Interactive comment on “Hydrological heterogeneity in Mediterranean reclaimed slopes: runoff and sediment yield at the patch and slope scales along a gradient of overland flow” by L. Merino-Martín et al.

L. Merino-Martín et al.

Received and published: 19 March 2012

Fig. 1.

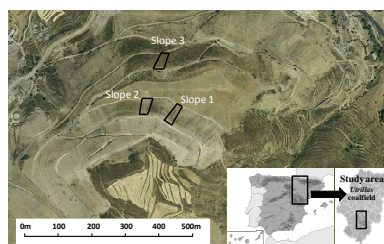
1) Methodology. Currently I do not think the description of experiments and calculations is sufficiently complete and precise to allow their reproduction by fellow scientists. A clear location map is required. The methodology also needs to be much more clearly explained. The text is currently too dense and hard to make sense of. For instance especially on P9933 it is difficult to understand how Gerlach troughs were used. Also why were TDR sensor deployed at 25 cm depths?

As proposed, we have improved these considerations in this section, improving the description of the study area, making the writing more comprehensive and clear, and adding a location map as a new figure (Fig. 1; Revision, section 2).
